VALUE ENGINEERING STUDY

Project # CSSTP-0007-00(692) PI No. 0007692

SR 92 from SR 120 to CR 473/Cedarcrest Road
Cobb/Paulding County, Georgia

31 January 2013

R-6.1 – Proposed Change 1 of 2

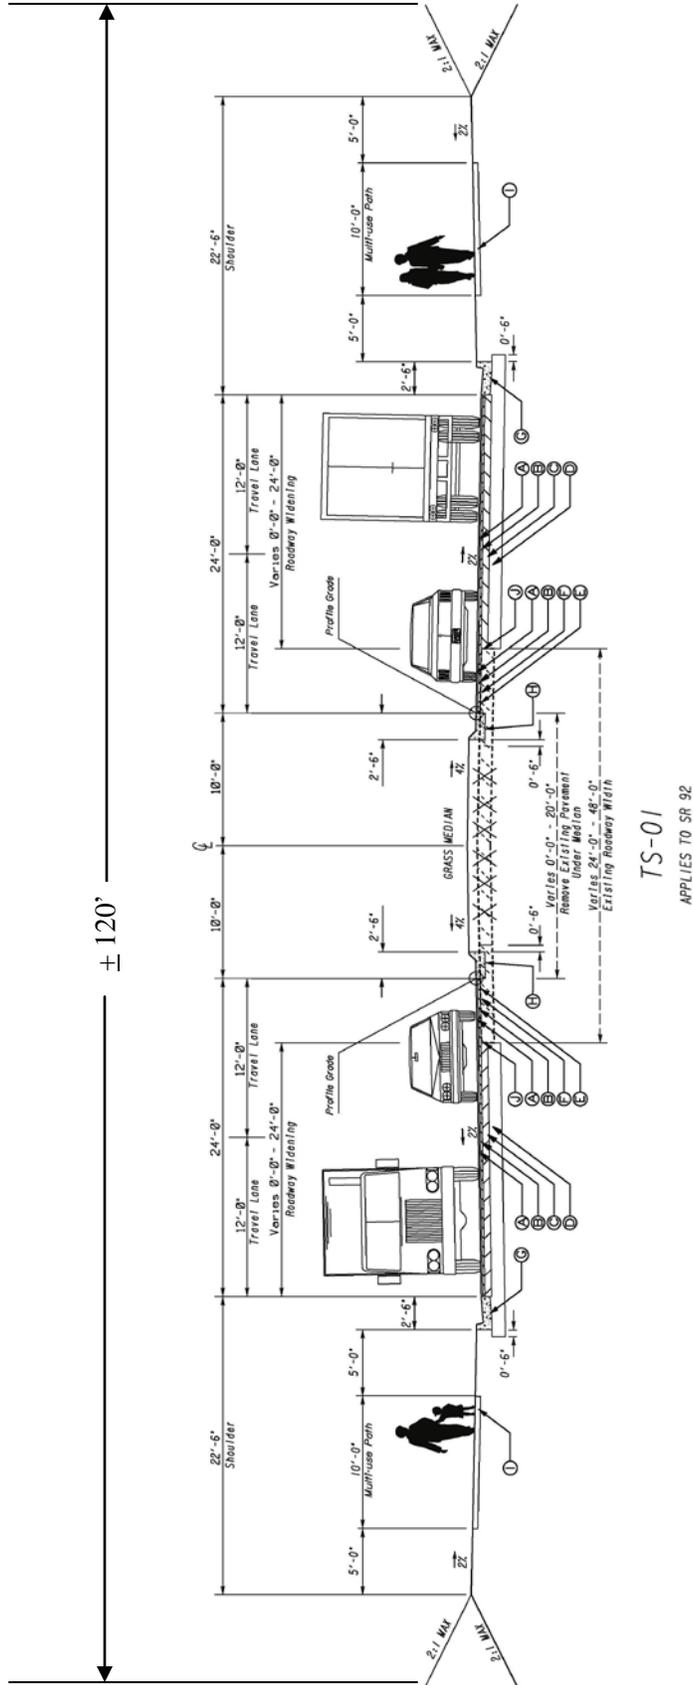
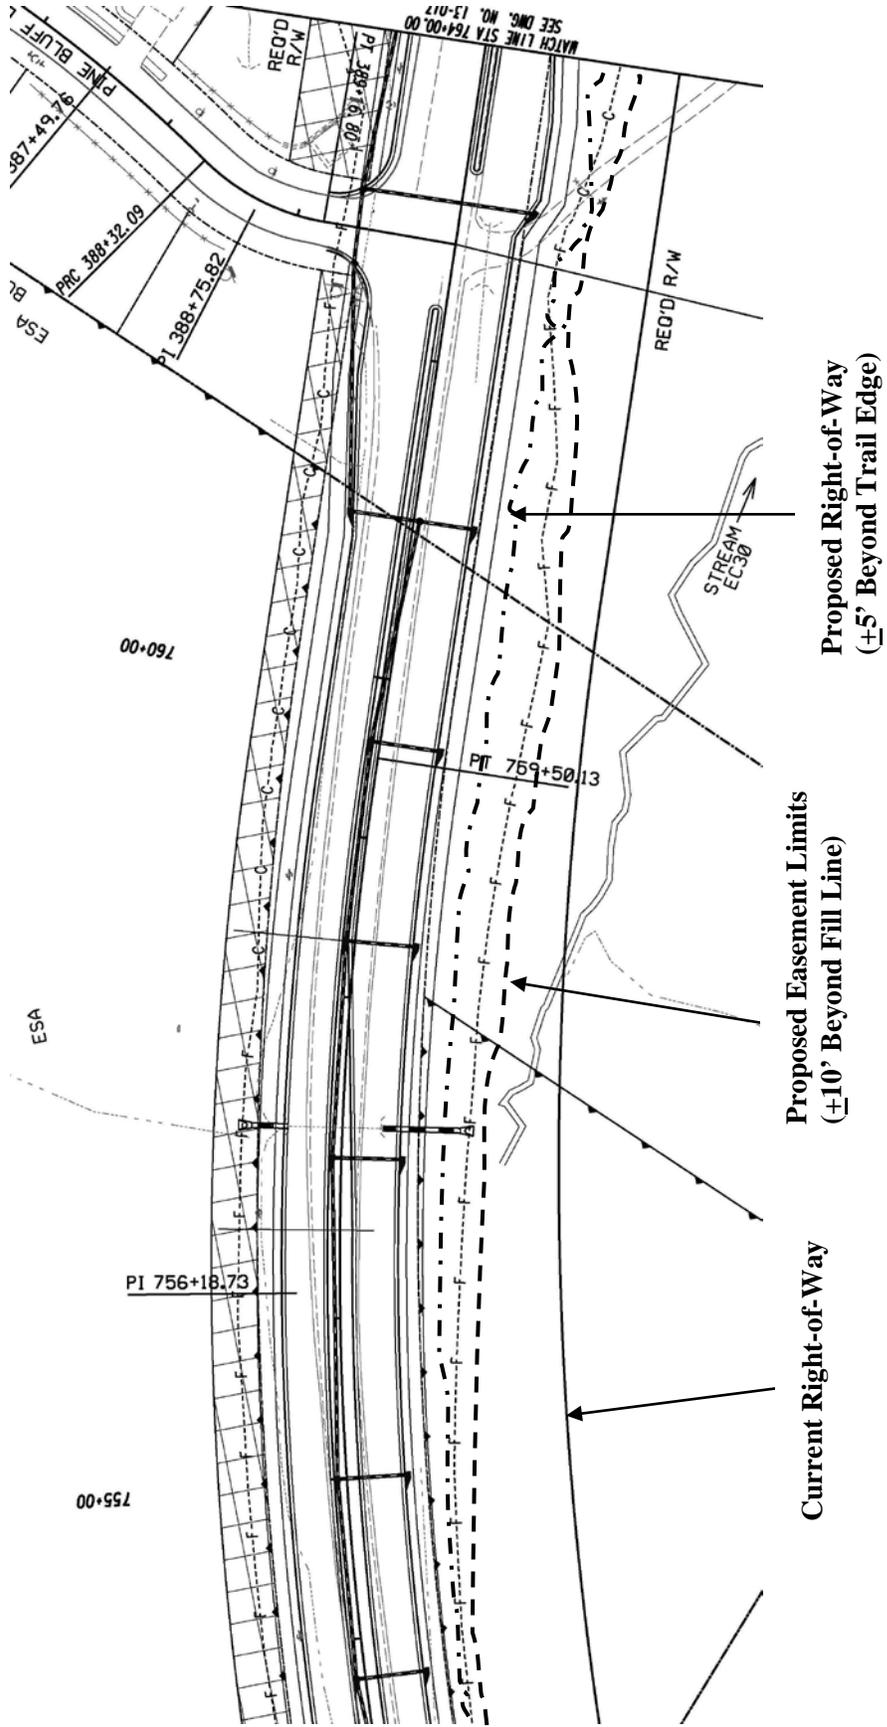
PROPOSED CHANGE: It is proposed to use a maximum right of way corridor of 120' with easements beyond the right of way in lieu of a right of way corridor of 200' to more than 300'.

PROPOSAL NUMBER: R-8.0

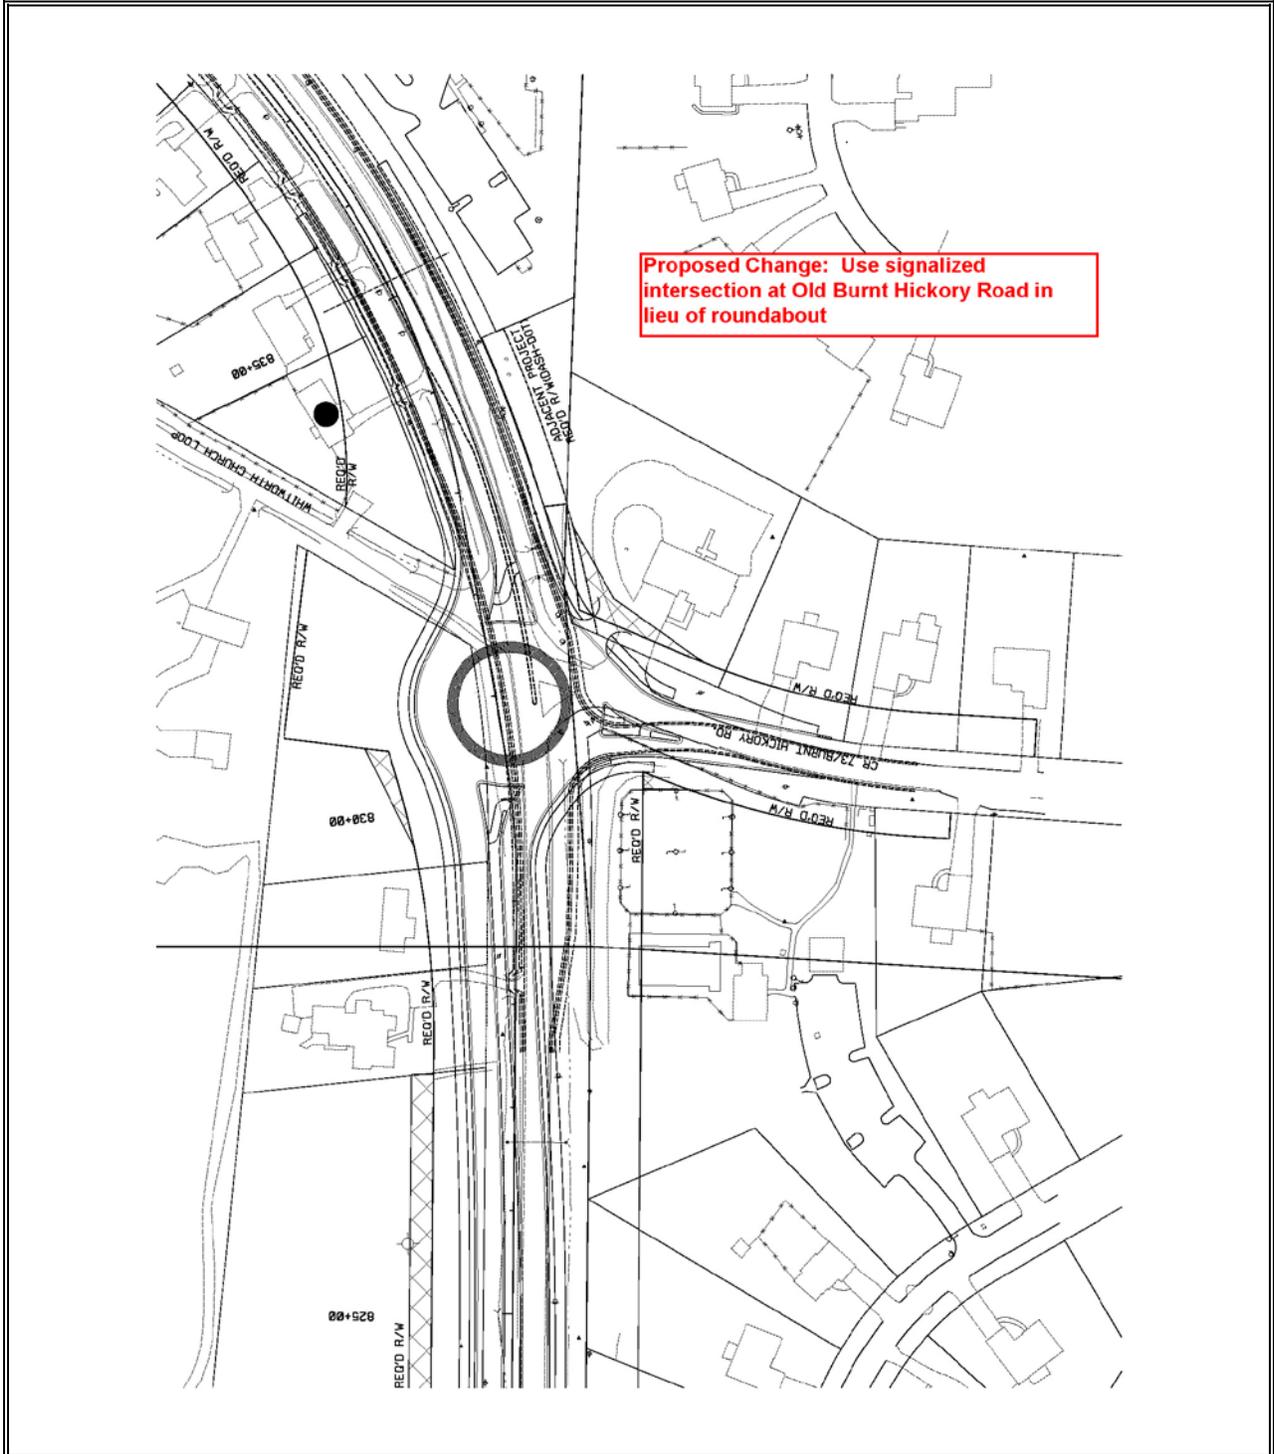
PROPOSED CHANGE: It is proposed to install a signalized intersection in lieu of a roundabout.

JUSTIFICATION: The traffic study performed by Kittelson & Associates dated January 2013 states in the Summary and Conclusions for SR 92 at Old Burnt Hickory Road that “Either a roundabout or traffic signal are needed to serve the 2037 design traffic volumes. Both options provide generally comparable performance and both are expected to be near capacity during the 2037 AM and PM peak hours.” Based on these statements in the Intersection Operations Analysis, the VE Team proposes to utilize a signalized intersection which provides comparable performance to a roundabout while also providing a cost savings to the project.

PROPOSAL NUMBER: R-9.0

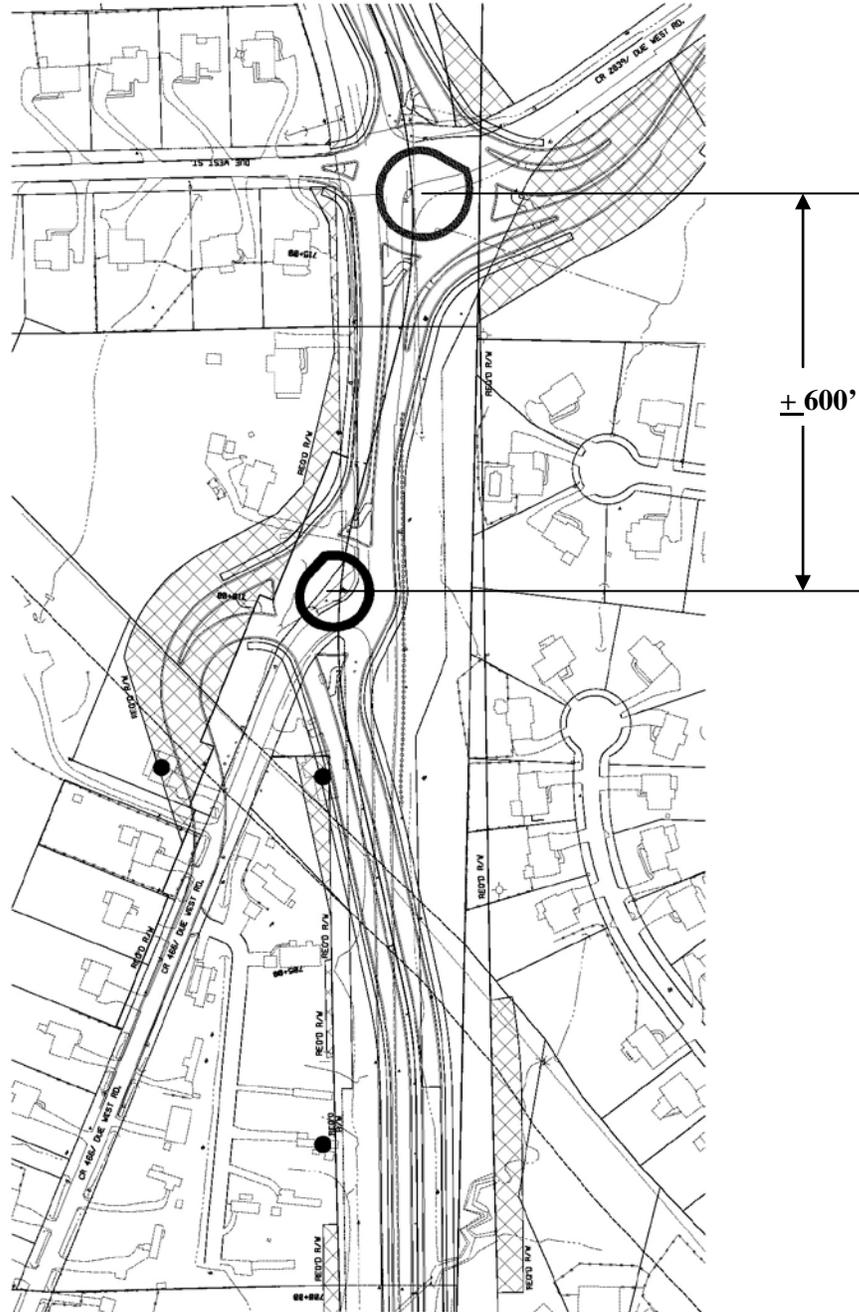
PROPOSED CHANGE: It is proposed to relocate the roundabout for Due West Road (South) approximately 800' South to approximate Sta 702+00 to obtain proper separation between intersections and to eliminate construction activities from the Colonial Pipeline easement (except area within the SR 92 right of way).

PROPOSAL NUMBER: R-9.1

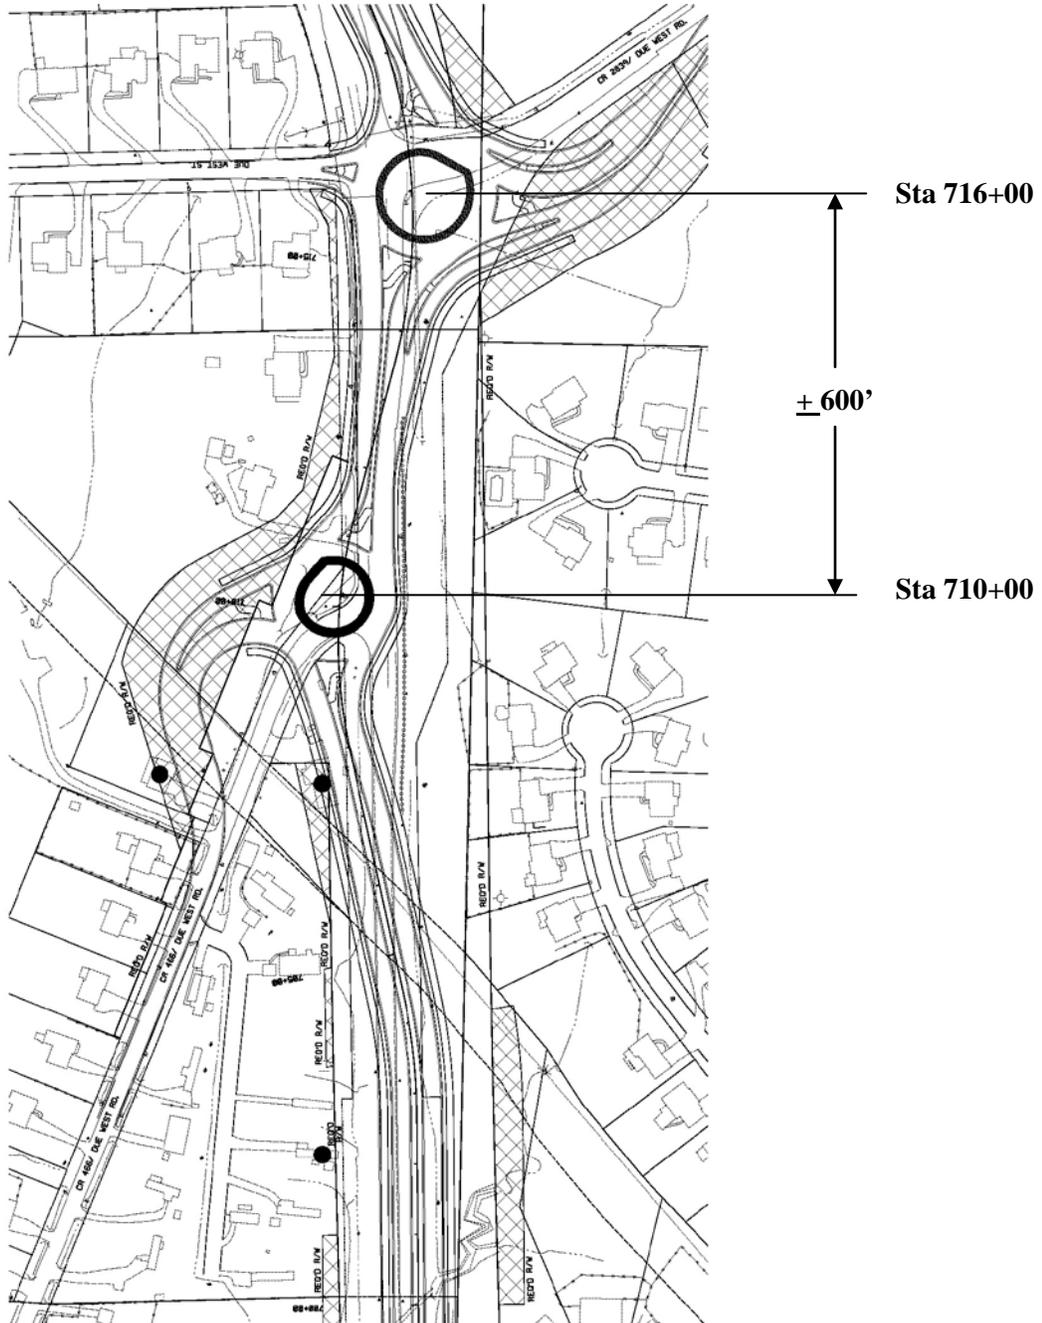
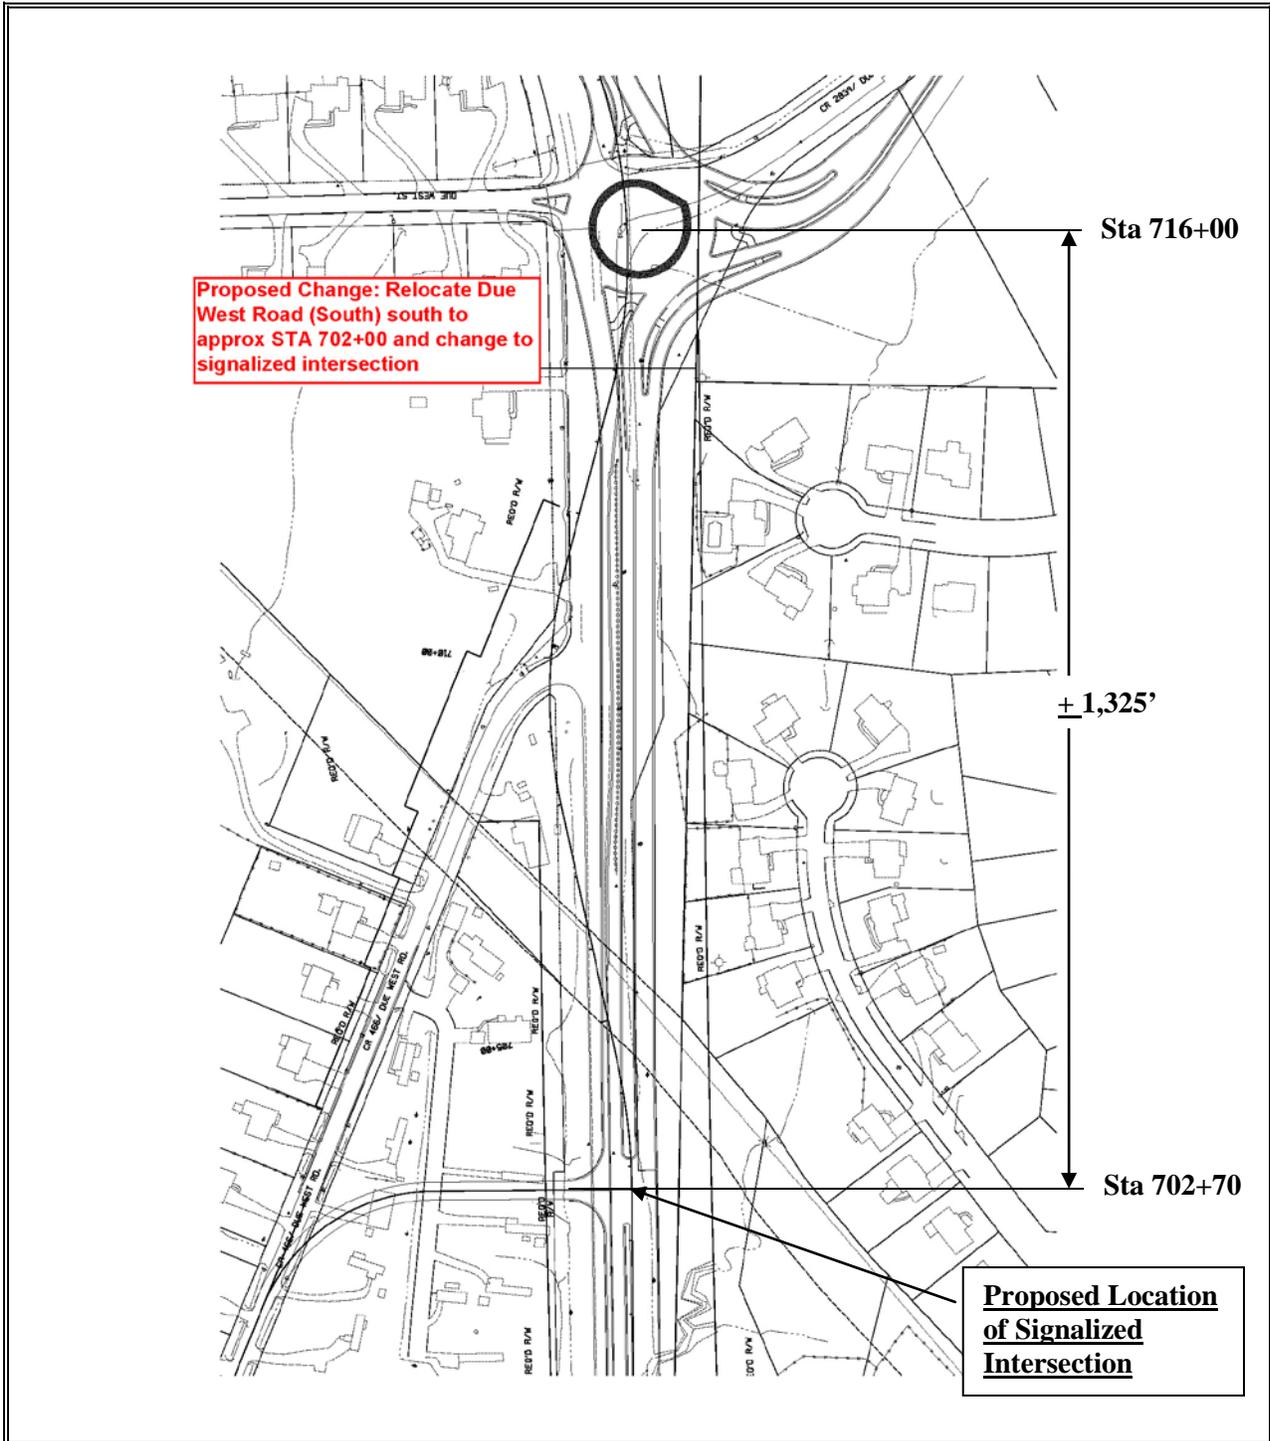
PROPOSED CHANGE: It is proposed to relocate the intersection for Due West Road (South) approximately 730' South to approximate Sta 702+70 and construct as a signalized intersection to obtain proper separation between intersections and to eliminate construction activities from the Colonial Pipeline easement (except area within the SR 92 right of way).
